## Product Discontinuation Notices

No. 2022058CE

**Discontinuation Notice of Pushbutton Switches Model A22NN, A22NL, A22NZ, A30NN, A30NZ series, Knob-type Selector Switches Model A22NS, A22NW, A22NZ, A30NS, A30NZ series, Key-type Selector Switches Model A22NK, A22NZ series of some models.**

[ Body color ]

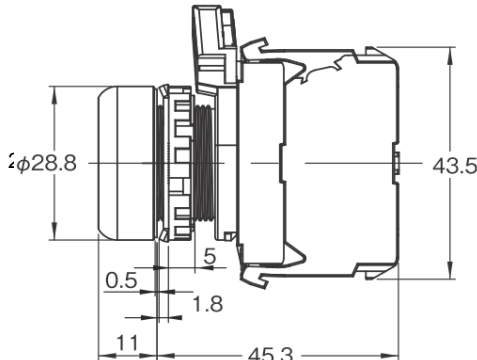
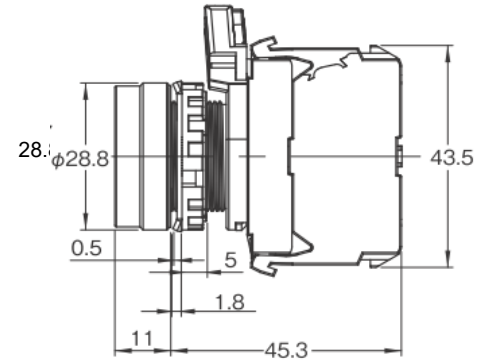
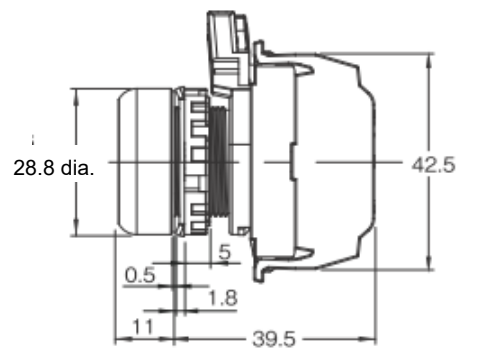
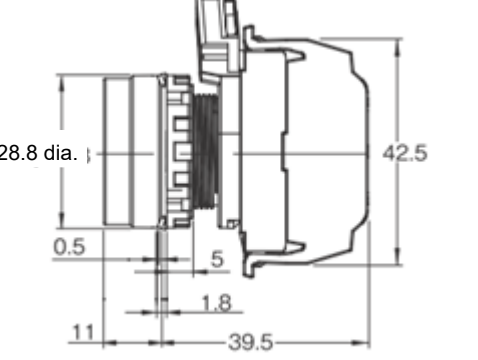
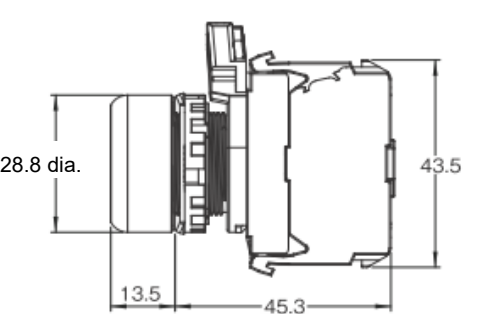
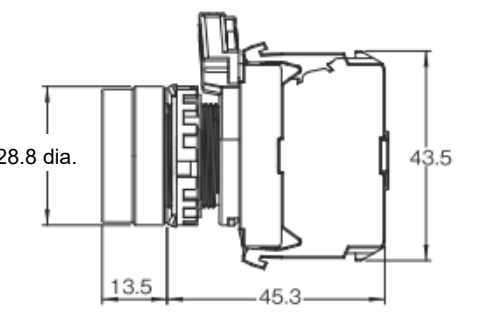
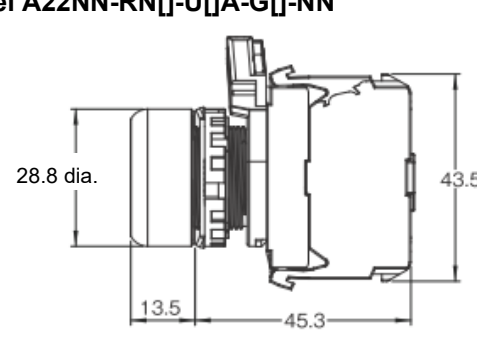
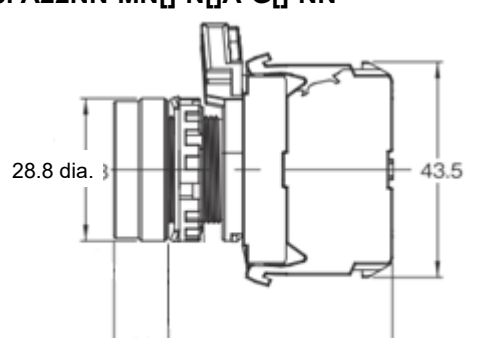
<p><b>Product discontinuation</b>  <b>Model A22N[]-R[], A22N[]-[]R[] series</b></p>	<p><b>Recommendable replacement</b>  <b>Model A22N[]-M[], A22N[]-[]M[] series</b></p>
<p><b>example :</b>  <b>A22NN-R[]series Metal bezel type</b></p> <p>Bezel: Glossy, No step</p>  <p>The image shows a metal bezel with a glossy finish and a smooth, flat surface. A red dot is placed on the bezel, with a red line pointing to the label 'Bezel' below it.</p> <p style="text-align: center;">Bezel</p>	<p><b>example :</b>  <b>A22NN-M[]series Brushed metal bezel type</b></p> <p>Bezel: Matte, with steps</p>  <p>The image shows a brushed metal bezel with a matte finish and a slightly stepped edge. A red dot is placed on the bezel, with a red line pointing to the label 'Bezel' below it.</p> <p style="text-align: center;">Bezel</p>

[ Body color ]

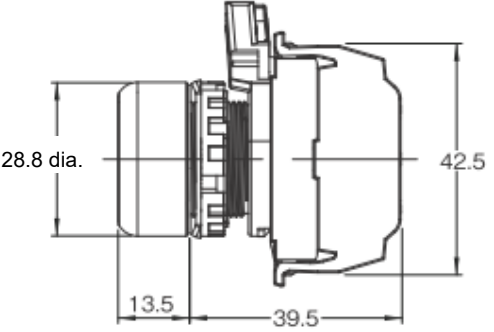
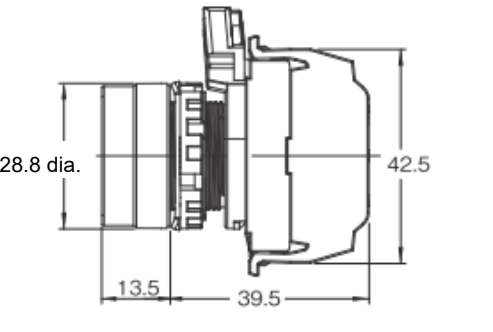
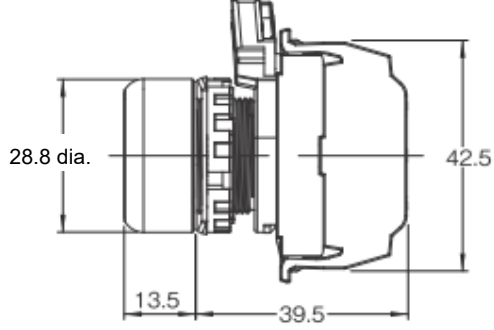
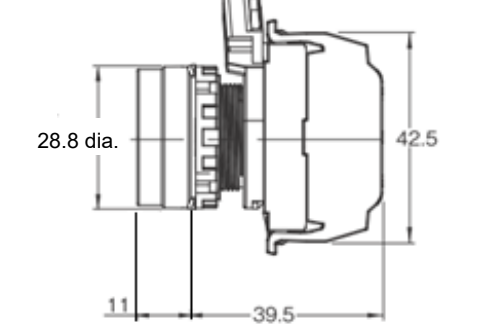
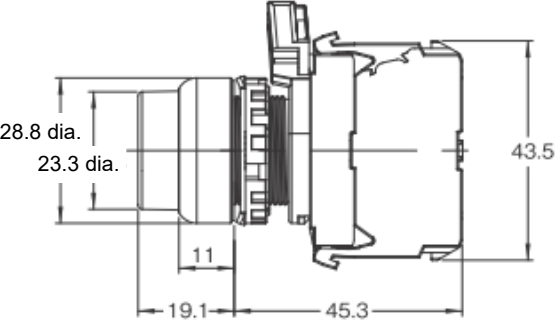
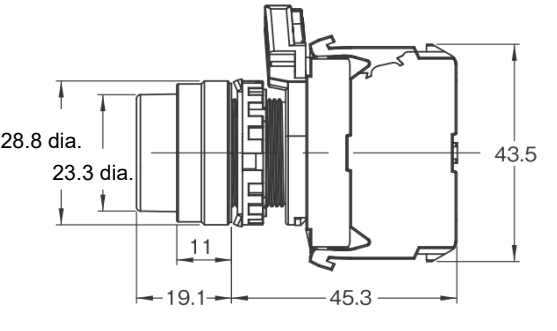
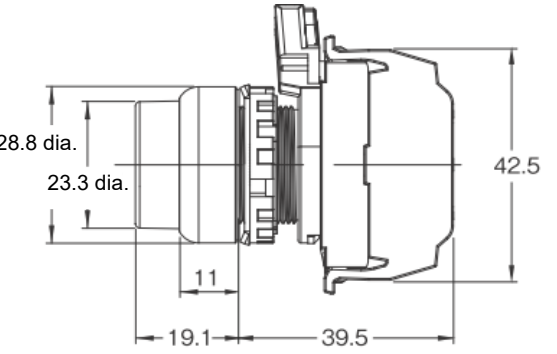
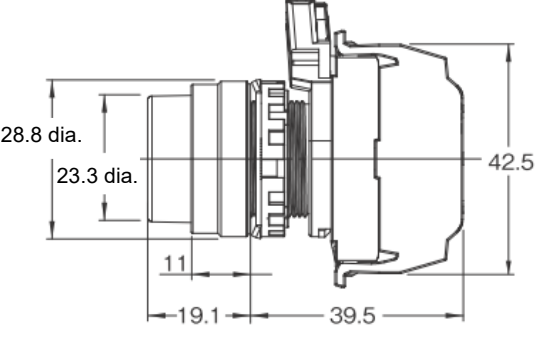
<b>Product discontinuation</b> <b>Model A22NN-□□□-U□, A22NZ-□□□-U□,</b> <b>A30NN-M□□-U□, A30NZ-M□□-U□ series</b>	<b>Recommendable replacement</b> <b>Model A22NN-□□□-N□, A22NZ-□□□-N□,</b> <b>A30NN-M□□-N□, A30NZ-M□□-N□ series</b>
<b>Button color</b> Red (Transparent) Model A22N□-□□□-UR series Model A30N□-M□□-UR series	<b>Button color</b> Red (Opaque) Model A22N□-□□□-NR series Model A30N□-M□□-NR series
Green(Transparent) Model A22N□-□□□-UG series Model A30N□-M□□-UG series	Green(Opaque) Model A22N□-□□□-NG series Model A30N□-M□□-NG series
Yellow(Transparent) Model A22N□-□□□-UY series Model A30N□-M□□-UY series	Yellow(Opaque) Model A22N□-□□□-NY series Model A30N□-M□□-NY series
White(Transparent) Model A22N□-□□□-UW series Model A30N□-M□□-UW series	White(Opaque) Model A22N□-□□□-NW series Model A30N□-M□□-NW series
Blue(Transparent) Model A22N□-□□□-UA series Model A30N□-M□□-UA series	Blue(Opaque) Model A22N□-□□□-NA series Model A30N□-M□□-NA series

Orange(Transparent) Model A22N□-□□□-UO series Model A30N□-M□□-UO series	Orange(Opaque) Model A22N□-□□□-NY series Model A30N□-M□□-NY series

[ Dimensions ]

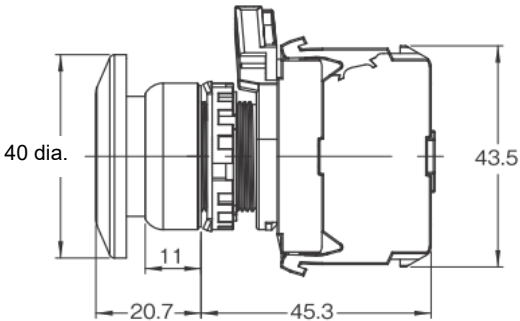
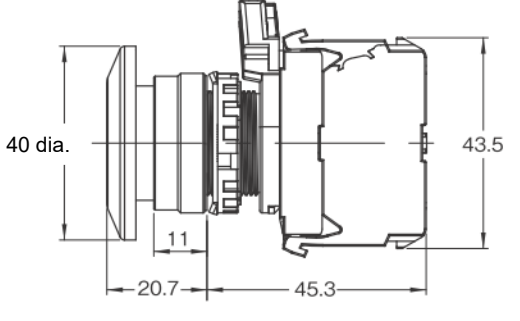
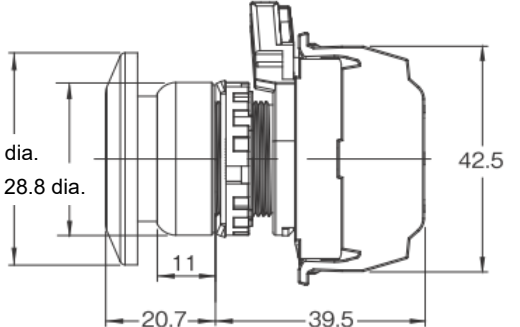
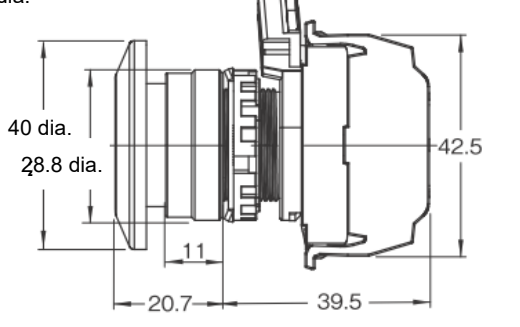
<p>Product discontinuation Model A22NN-R[], A22NL-R[], A22NZ-R[] series</p>	<p>Recommendable replacement Model A22NN-M[], A22NL-M[], A22NZ-M[] series</p>
<p><b>Metal bezel type</b> Model A22NN-RN[]-N[]A-G[]-NN</p> 	<p><b>Brushed metal bezel type</b> Model A22NN-MN[]-N[]A-G[]-NN</p> 
<p>Model A22NN-RN[]-N[]A-P[]-NN</p> 	<p>Model A22NN-MN[]-N[]A-P[]-NN</p> 
<p>Model A22NL-RN[]-T[]A-G[]-[]</p> 	<p>Model A22NL-MN[]-T[]A-G[]-[]</p> 
<p>Model A22NN-RN[]-U[]A-G[]-NN</p> 	<p>Model A22NN-MN[]-N[]A-G[]-NN</p>

[ Dimensions ]

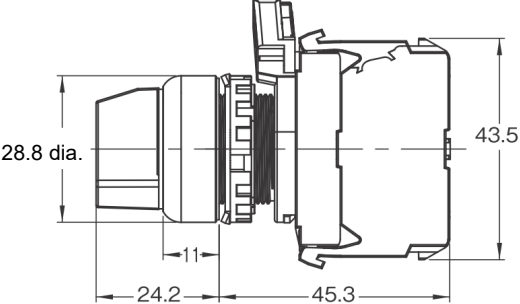
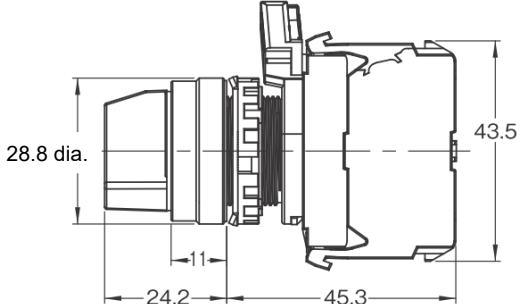
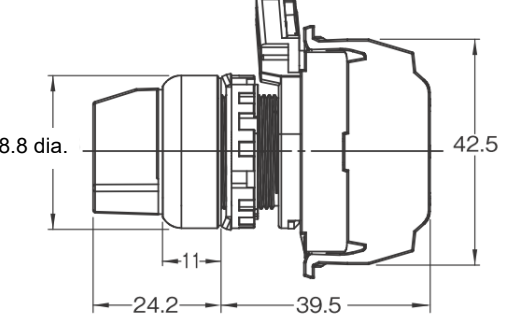
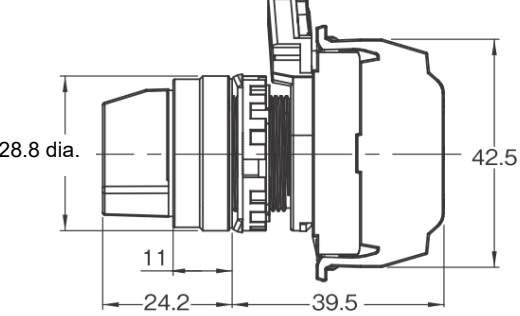
<p>Product discontinuation Model A22NN-R[], A22NL-R[], A22NZ-R[] series</p>	<p>Recommendable replacement Model A22NN-M[], A22NL-M[], A22NZ-M[] series</p>
<p><b>Metal bezel type</b> Model A22NL-RN[]-T[]A-P[]-[]</p> 	<p><b>Brushed metal bezel type</b> Model A22NL-MN[]-T[]A-P[]-[]</p> 
<p>Model A22NN-RN[]-U[]A-P[]-NN</p> 	<p>Model A22NN-MN[]-N[]A-P[]-NN</p> 
<p>Model A22NN-RP[]-[]A-G[]-NN</p> 	<p>Model A22NN-MP[]-[]A-G[]-NN</p> 
<p>Model A22NN-RP[]-[]A-P[]-NN</p> 	<p>Model A22NN-MP[]-[]A-P[]-NN</p>

[ Dimensions ]

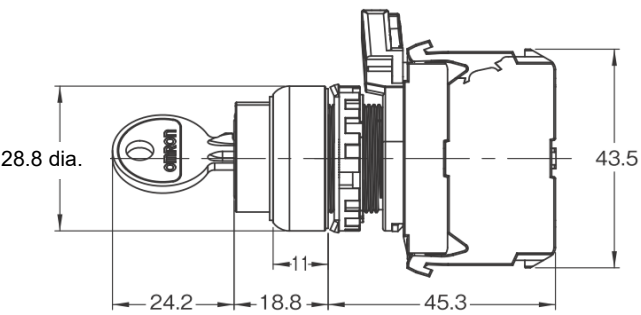
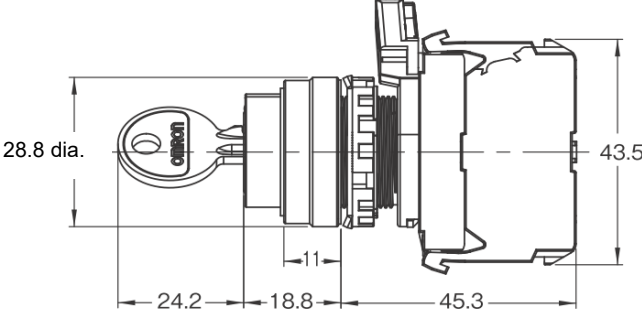
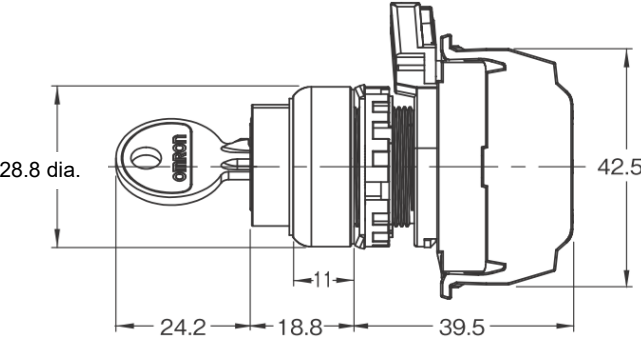
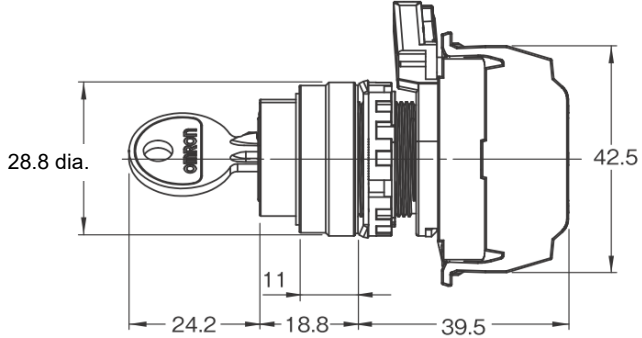
<b>Product discontinuation</b> <b>Model A22NN-R[], A22NL-R[], A22NZ-R[] series</b>	<b>Recommendable replacement</b> <b>Model A22NN-M[], A22NL-M[], A22NZ-M[] series</b>
<p><b>Metal bezel type</b>  <b>Model A22NL-RM[]-[]A-G[]-[]</b></p> 	<p><b>Brushed metal bezel type</b>  <b>Model A22NL-MM[]-[]A-G[]-[]</b></p> 
<p><b>Model A22NN-RM[]-[]A-P[]-NN</b></p> 	<p><b>Model A22NN-MM[]-[]A-P[]-NN</b>  40 dia.</p>

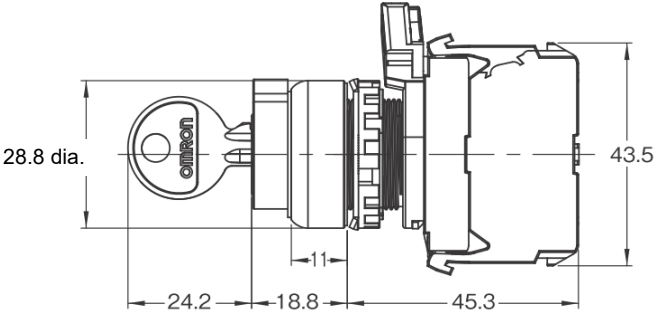
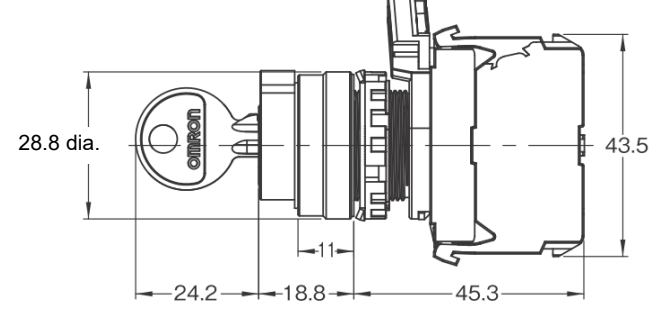
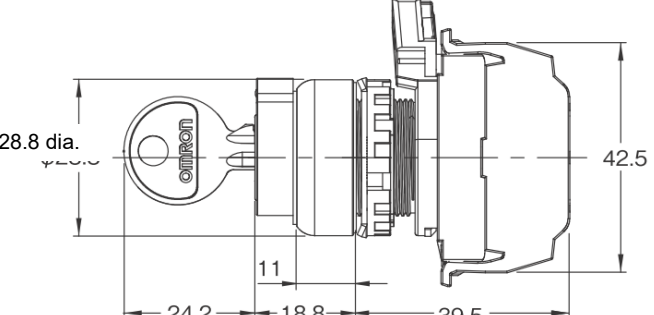
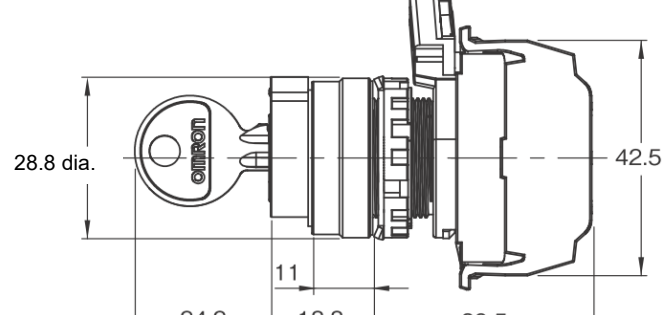
<b>Product discontinuation</b> <b>Model A22NS-[]R[], A22NW-[]R[], A22NZ-[]R[] series</b>	<b>Recommendable replacement</b> <b>Model A22NS-[]M[], A22NW-[]M[], A22NZ-[]M[] series</b>
<p><b>Metal bezel type</b>  <b>Model A22NS-2R[]-[]A-G[]-NN</b>  <b>Model A22NW-2R[]-[]A-G[]-[]</b></p> 	<p><b>Brushed metal bezel type</b>  <b>Model A22NS-2M[]-[]A-G[]-NN</b>  <b>Model A22NW-2M[]-[]A-G[]-[]</b></p> 
<p><b>Model A22NS-2R[]-[]A-P[]-NN</b>  <b>Model A22NW-2R[]-[]A-P[]-[]</b></p> 	<p><b>Model A22NS-2M[]-[]A-P[]-NN</b>  <b>Model A22NW-2M[]-[]A-P[]-[]</b></p>

[ Dimensions ]

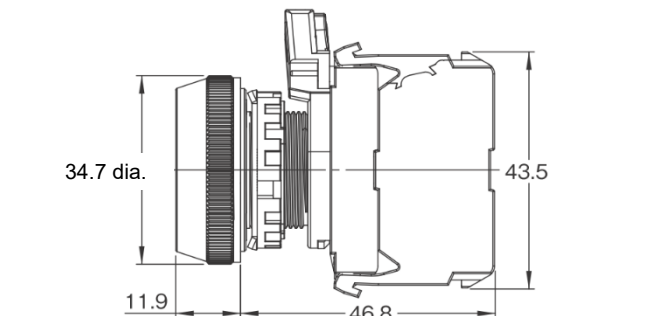
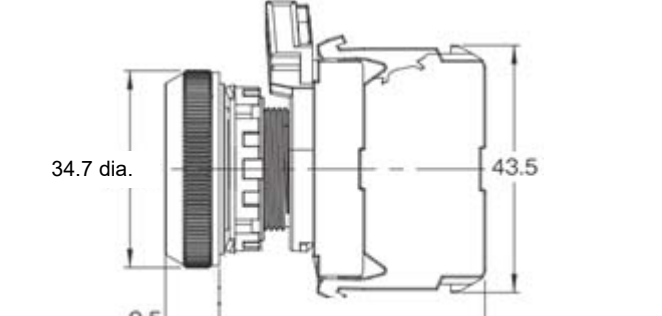
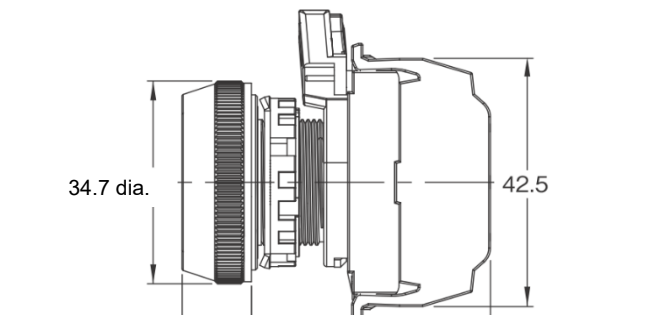
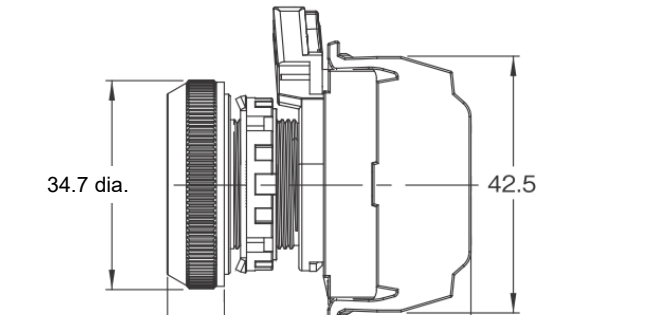
<p><b>Product discontinuation</b>                      Model A22NS-[]R[], A22NW-[]R[],                      A22NZ-[]R[] series</p>	<p><b>Recommendable replacement</b>                      Model A22NS-[]M[], A22NW-[]M[],                      A22NZ-[]M[] series</p>
<p><b>Metal bezel type</b>                      Model A22NS-3R[]-[]A-G[]-NN                      Model A22NW-3R[]-[]A-G[]-[]</p>  <p>28.8 dia. 43.5 11 24.2 45.3</p>	<p><b>Brushed metal bezel type</b>                      Model A22NS-3M[]-[]A-G[]-NN                      Model A22NW-3M[]-[]A-G[]-[]</p>  <p>28.8 dia. 43.5 11 24.2 45.3</p>
<p><b>Model A22NS-3R[]-[]A-P[]-NN</b>  <b>Model A22NW-3R[]-[]A-P[]-[]</b></p>  <p>28.8 dia. 27.4 dia. 42.5 11 24.2 39.5</p>	<p><b>Model A22NS-3M[]-[]A-P[]-NN</b>  <b>Model A22NW-3M[]-[]A-P[]-[]</b></p>  <p>28.8 dia. 27.4 dia. 42.5 11 24.2 39.5</p>

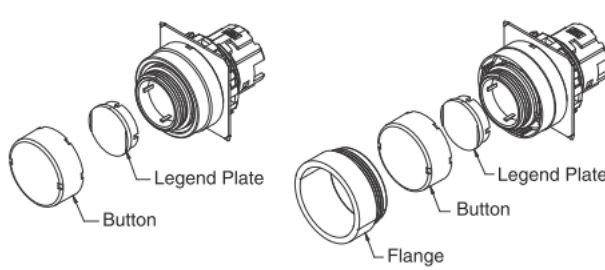
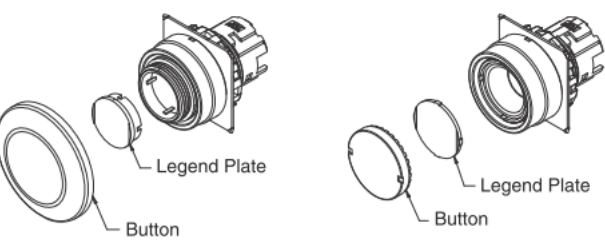
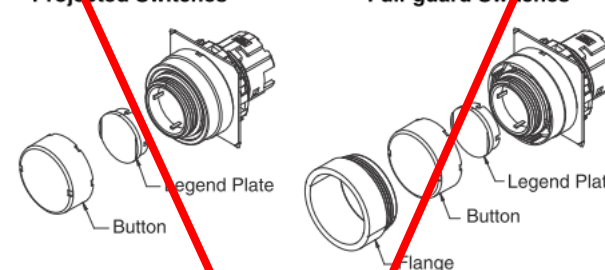
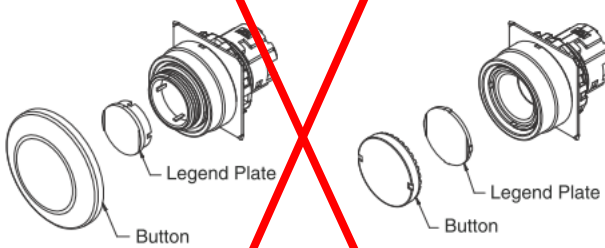
<p><b>Product discontinuation</b>                      Model A22NK-[]R[], A22NZ-[]R[] series</p>	<p><b>Recommendable replacement</b>                      Model A22NK-[]M[], A22NZ-[]M[] series</p>
<p><b>Metal bezel type</b>                      Model A22NK-2R[]-[]A-G[]-NN</p>  <p>28.8 dia. 43.5 11 24.2 18.8 45.3</p>	<p><b>Brushed metal bezel type</b>                      Model A22NK-2M[]-[]A-G[]-NN</p>  <p>28.8 dia. 43.5 11 24.2 18.8 45.3</p>
<p><b>Model A22NK-2R[]-[]A-P[]-NN</b></p>  <p>28.8 dia. 42.5 11 24.2 18.8 39.5</p>	<p><b>Model A22NK-2M[]-[]A-P[]-NN</b></p>  <p>28.8 dia. 42.5 11 24.2 18.8 39.5</p>
